**CASE NO. FP-2022-0020
ORDER OF CONDITIONAL
APPROVAL OF FINAL PLAT**

HEARING DATE: 9/6/2022
TO: Mayor & City Council
FROM: Sonya Allen, Associate Planner
208-884-5533
SUBJECT: FP-2022-0020; A-2022-0150
Acclima Subdivision (aka Aviator Springs)
LOCATION: 3235 N. McDermott Rd., in the SE 1/4 of Section 32, T.4N., R.1W.

Final plat consisting of one (1) buildable lot on 6.70 acres of land in the M-E zoning district for Acclima Subdivision. *Note: This is the second phase of the Aviator Springs preliminary plat (H-2021-0065).*

B. Final Plat (dated: 5/31/22)

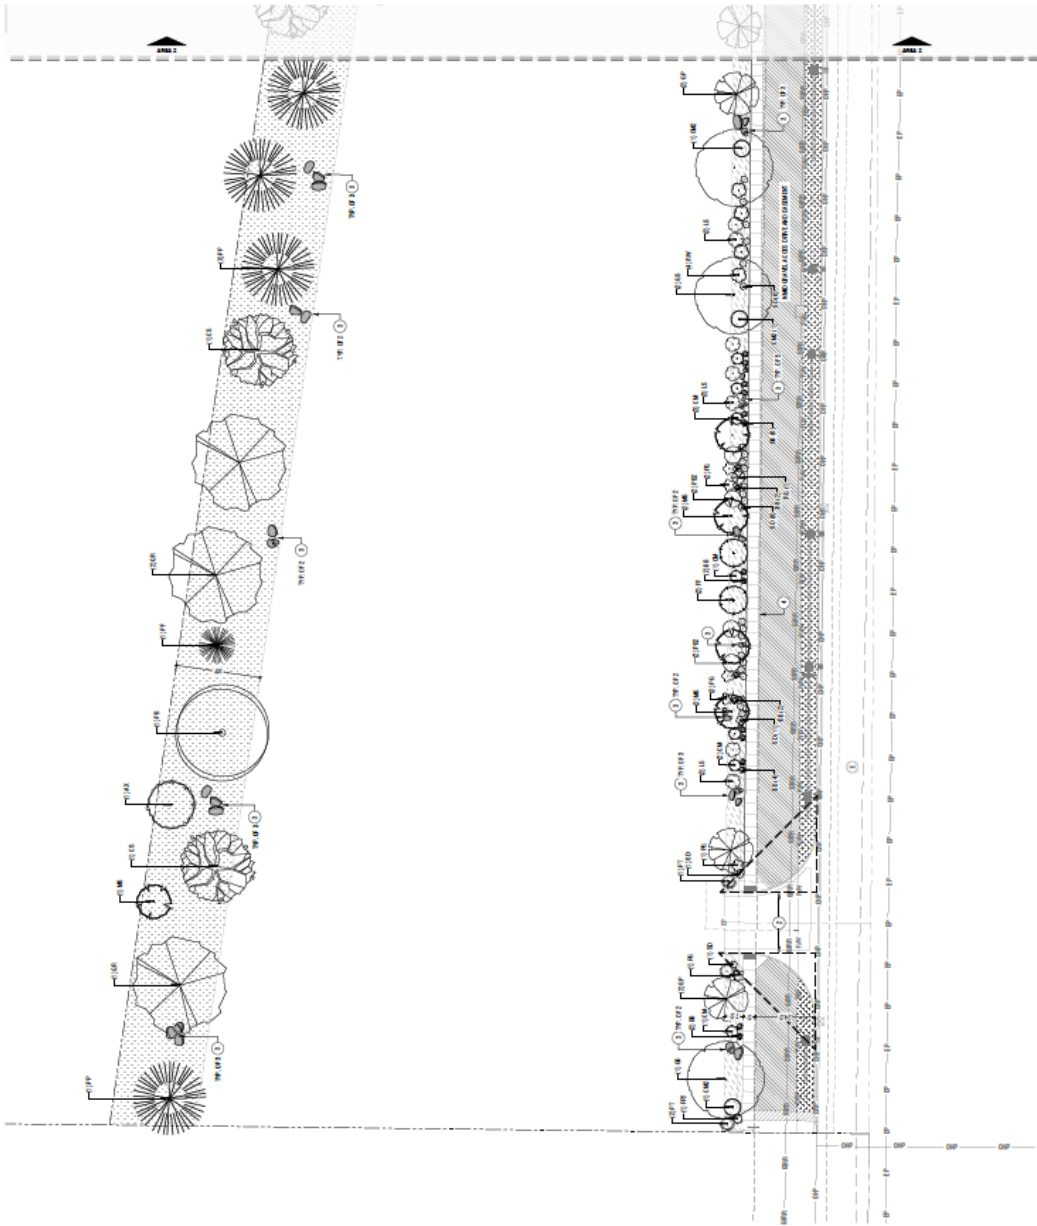
3. Prior to submittal for the City Engineer's signature, have the Certificate of Owners and the accompanying acknowledgement signed and notarized.
4. The final plat prepared by The Land Group, stamped by James R. Washburn, dated: 5/31/2022, included in Section V.B shall be revised as follows:

- a. Depict a minimum 35-foot wide street buffer along N. McDermott Rd., an entryway corridor, in a common lot or a permanent dedicated buffer in accord with UDC 11-3B-7C.2a.

- b. Modify plat note #7 as follows: "The landscape buffers shown hereon shall be ~~owned and~~ maintained by the property owner."

A copy of the revised plat shall be submitted with the final plat for City Engineer signature.

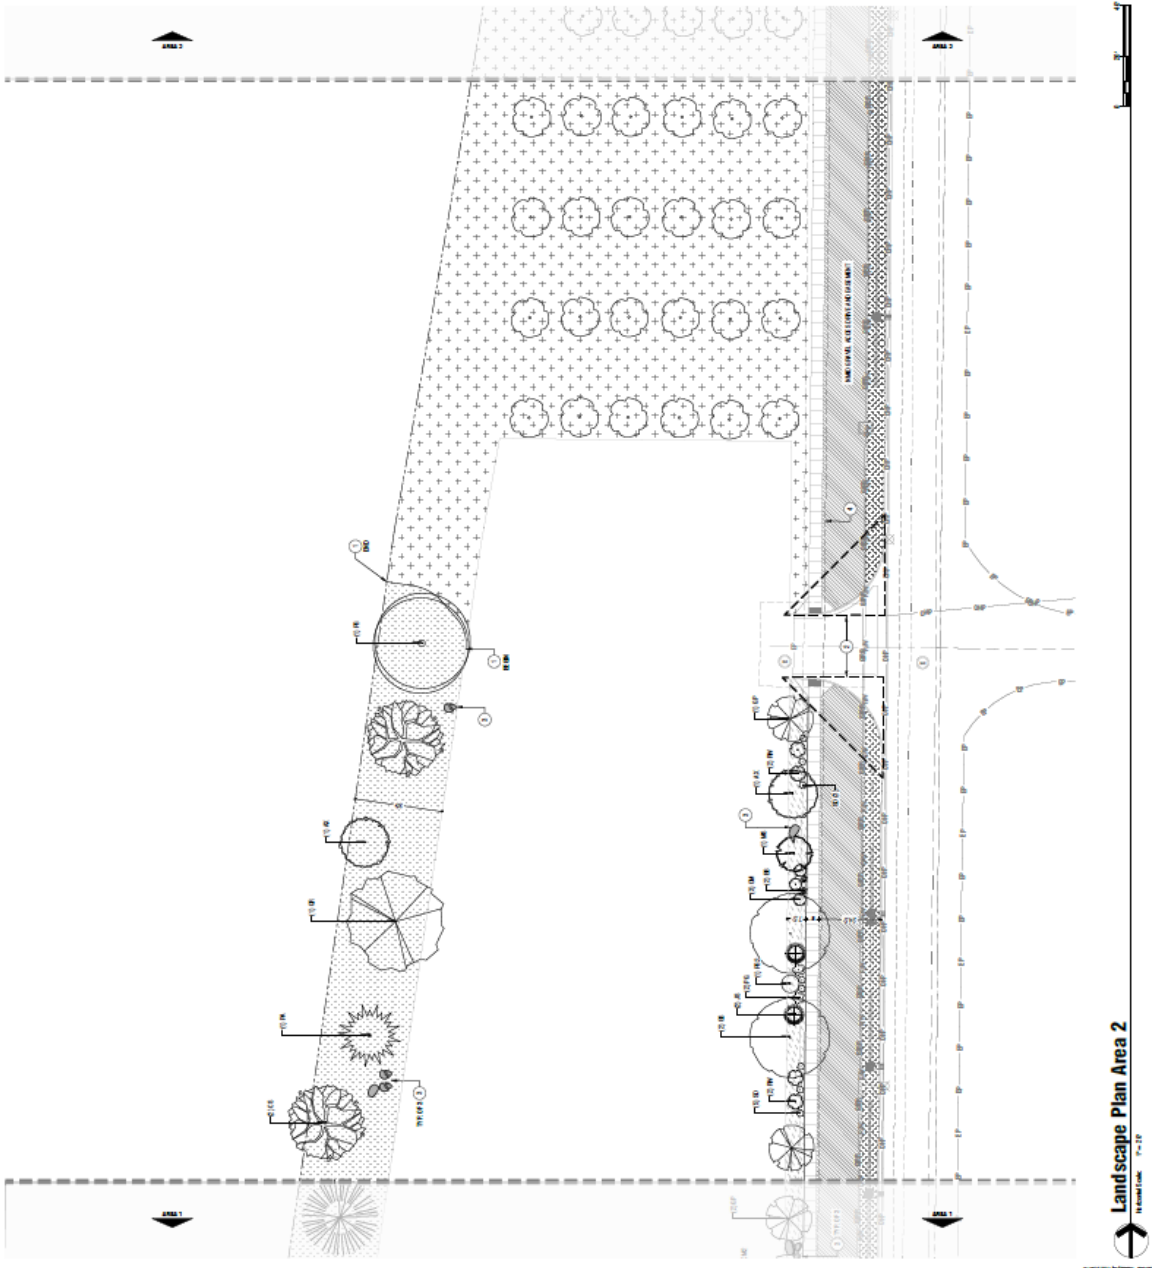
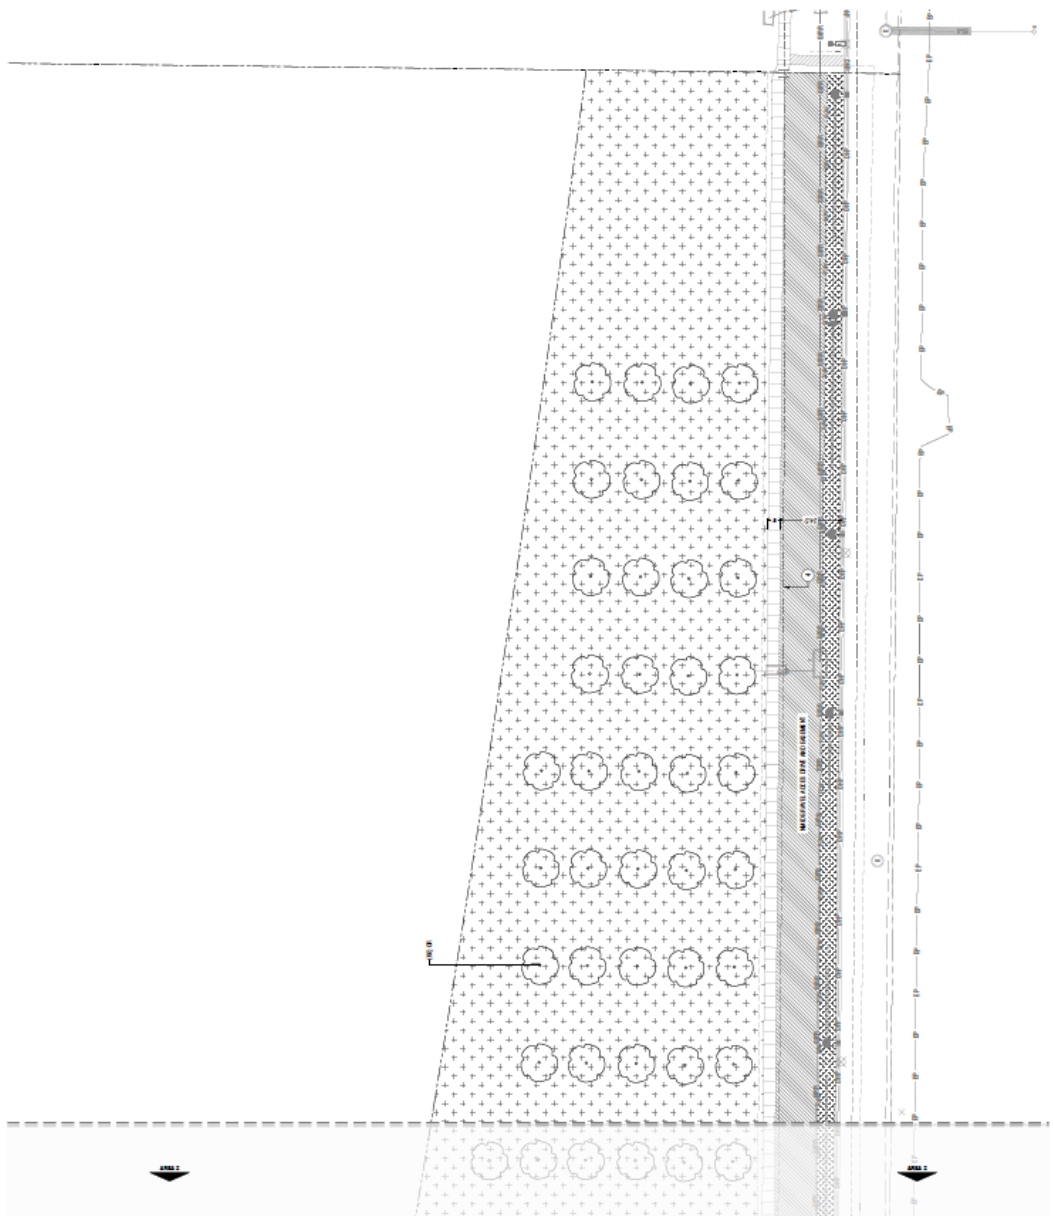
5. The landscape plan prepared by The Land Group, Inc., dated 7/12/2022, included in Section V.C, shall be revised as follows:
 - a. Depict shrubs and vegetative groundcover within the 35-foot wide street buffers along N. McDermott Rd. and future SH-16 in accord with the standards listed in UDC [11-3B-7C.3a](#). *Alternative compliance was approved to the standards in UDC 11-3B-7C.3b, which require trees within the street buffer, to allow an orchard in lieu of street trees on the northern 1/3 of the property within the street buffers along future SH-16 and N. McDermott Rd.*
 - b. Evenly disperse the trees in the orchard over the entire northern portion of the property. *The orchard trees are not required to be installed until the time of lot development.*

A copy of the revised landscape plan shall be submitted with the final plat for City Engineer signature.
